Discussion of SEMI P38-1102 and blue ballot 3688

SPECIFICATION FOR ABSORBING
FILM STACKS and MULTILAYERS
ON EXTREME ULTRAVIOLET
LITHOGRAPHY MASK BLANKS

Discussion of SEMI P37-1102 from 10-14-2002

SPECIFICATION FOR EXTREME ULTRAVIOLET LITHOGRAPHY MASK SUBSTRATES

Proposed mask layout (Figure 1)

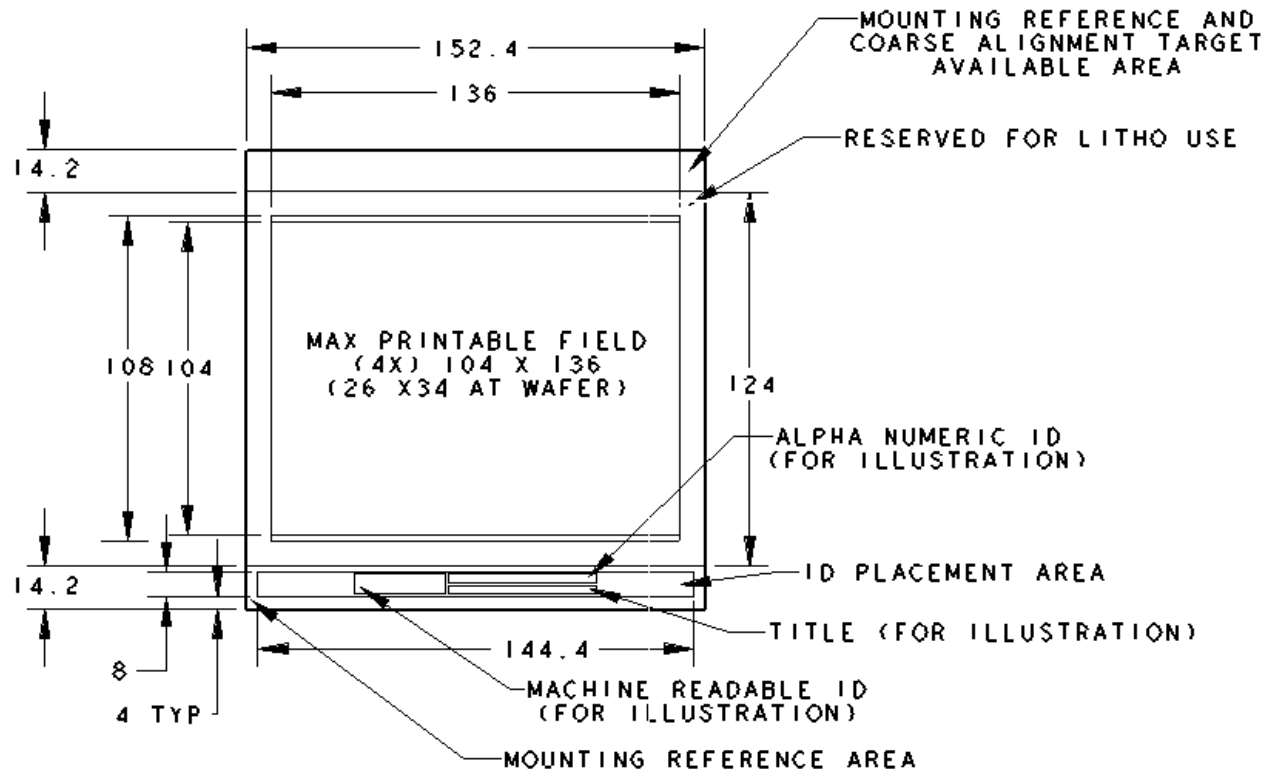
- Provided by SVG in 2000 and might need updating.
